AGENDA ITEM: 5.5

To: Development Assessment Panel (DAP) on 14 November 2016

Proposal: Four Storey Residential Flat Building Comprising 12 Dwellings with associated Car Parking (DA 050/341/2016)

Address: 9 Allan Street, Prospect (CT 6169/714)

DRAWING TITLE	REV	PAGE NO.
SITE PLAN	A	PL100

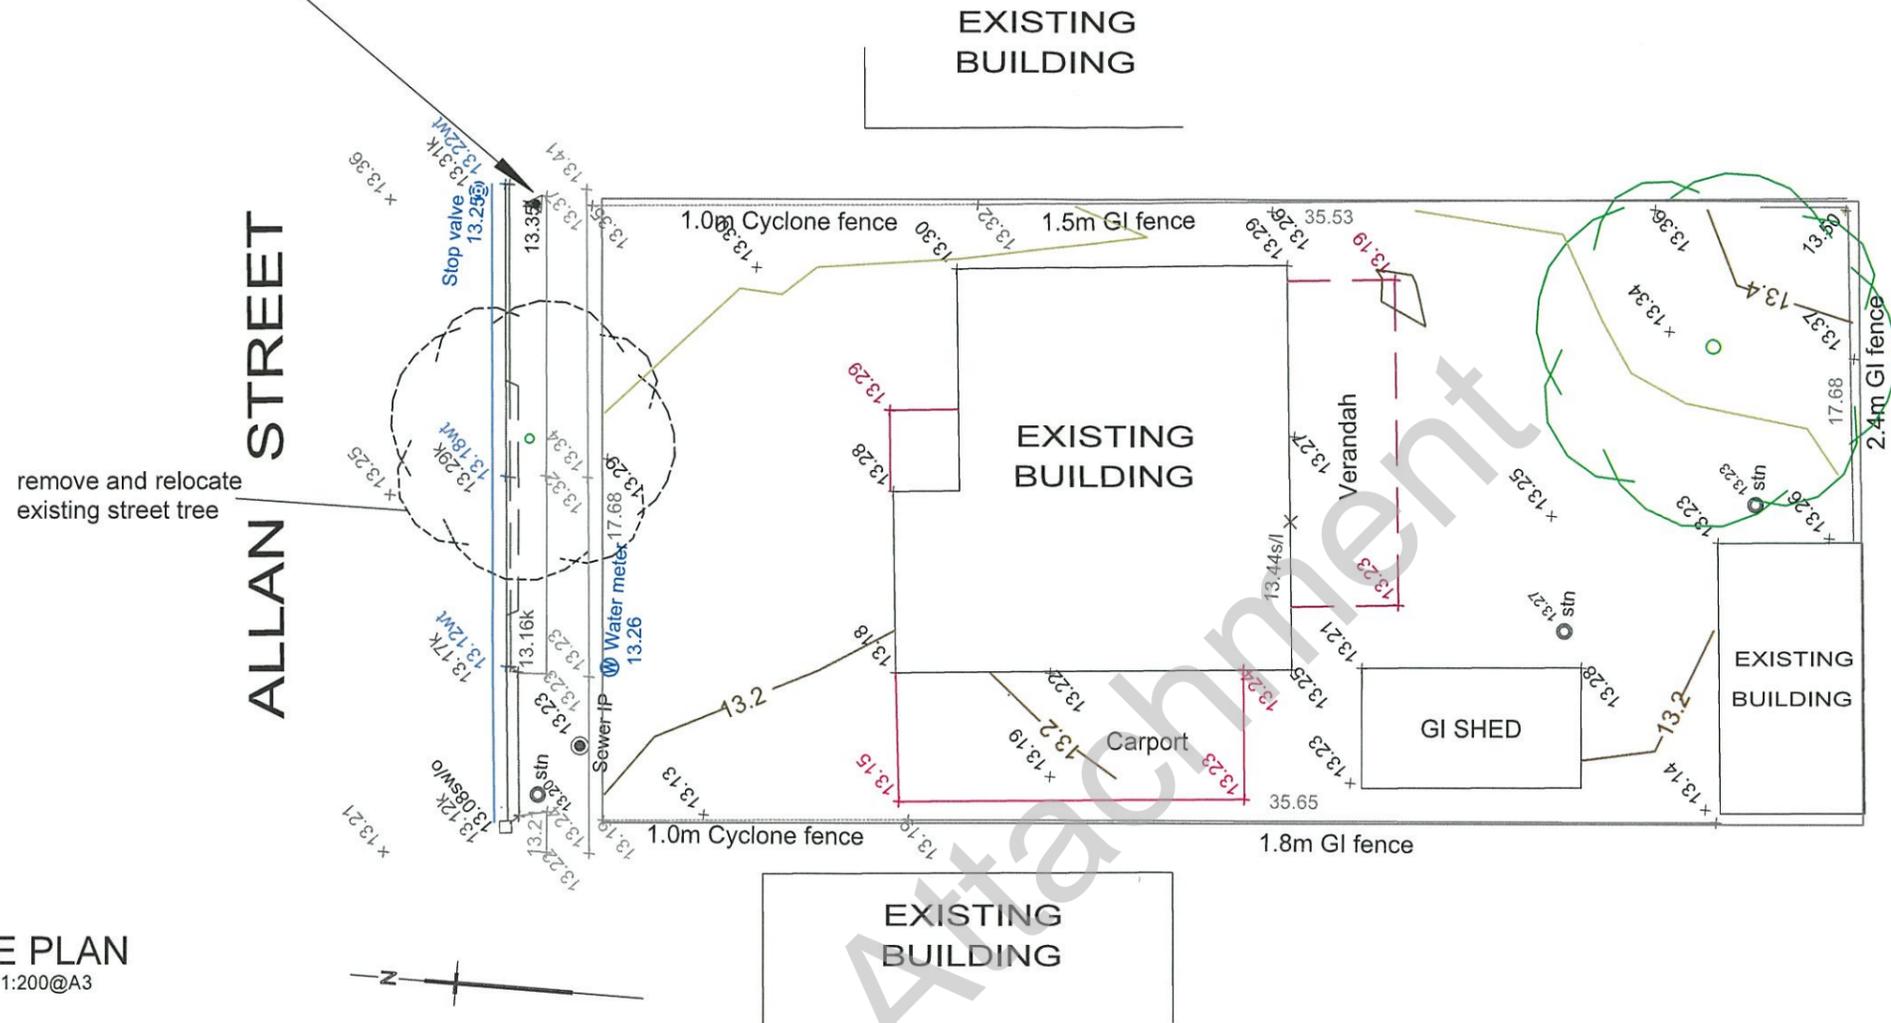
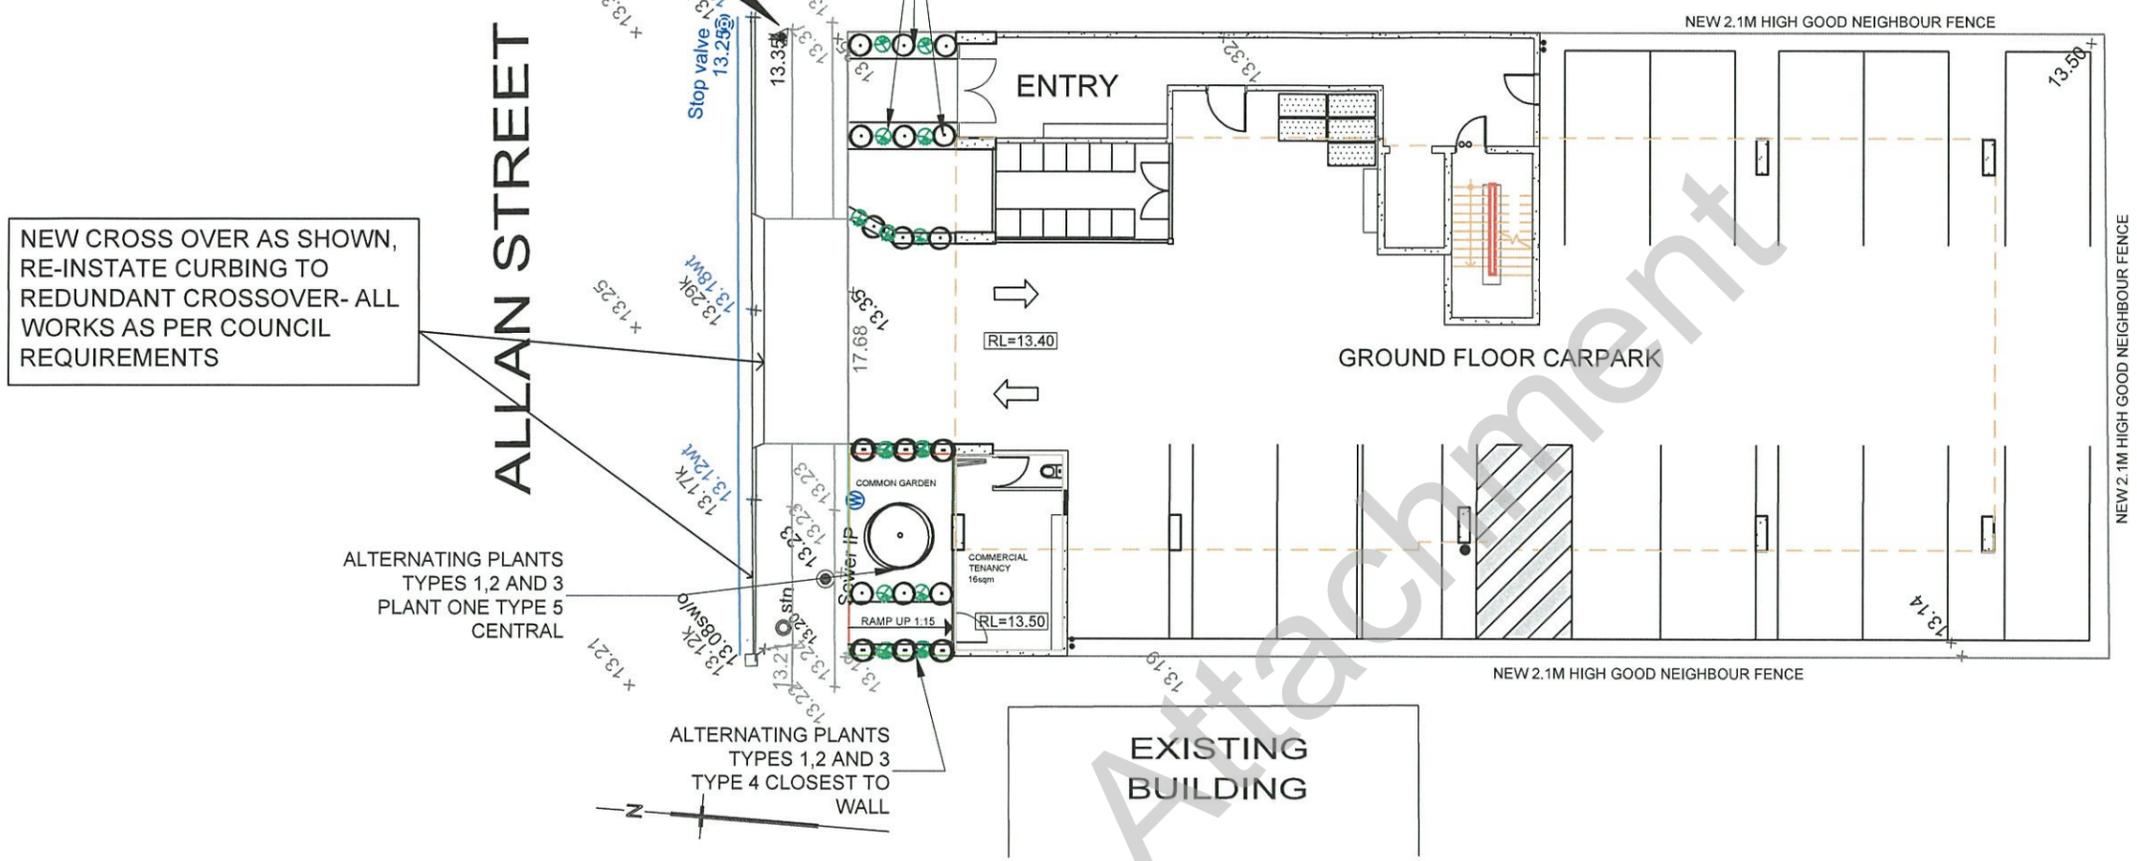
- 7.4.3 The applicant has provided finished floor level details and a basic stormwater management plan. The finished floor level (FFL) of the ground floor car park has been designed in accordance with the minimal slope of the land, being 180mm above the highest point of the water table adjacent the north east corner of the subject land. The proposed FFL of the commercial tenancy at 13.50 would be 380mm above the water table adjacent.

- 7.4.6 The current dwelling on the subject land has a FFL of 13.44 and as such, the proposed FFL of 13.40 would be lower than that of the existing dwelling. As desired by Council's engineers, the FFL should provide 150mm minimum above flood level. The proposed FFL would not achieve this.

- 7.4.9 The proposal would result in an increase in stormwater run-off from the subject land and the ground floor levels may need to be increased slightly. It is therefore appropriate that Council receive and assess a detailed stormwater management plan. To this end, it is recommended that the consideration of the stormwater design be reserved for further assessment and approval by Council.

1. A detailed stormwater management plan shall be provided, and shall demonstrate that post-development outflow rates from the site will match pre-development rates in 1 in 20 ARI storm events. The location and capacity of any on-site detention tanks, as well as the extent of any fill and associated retaining walls, shall be clearly described.
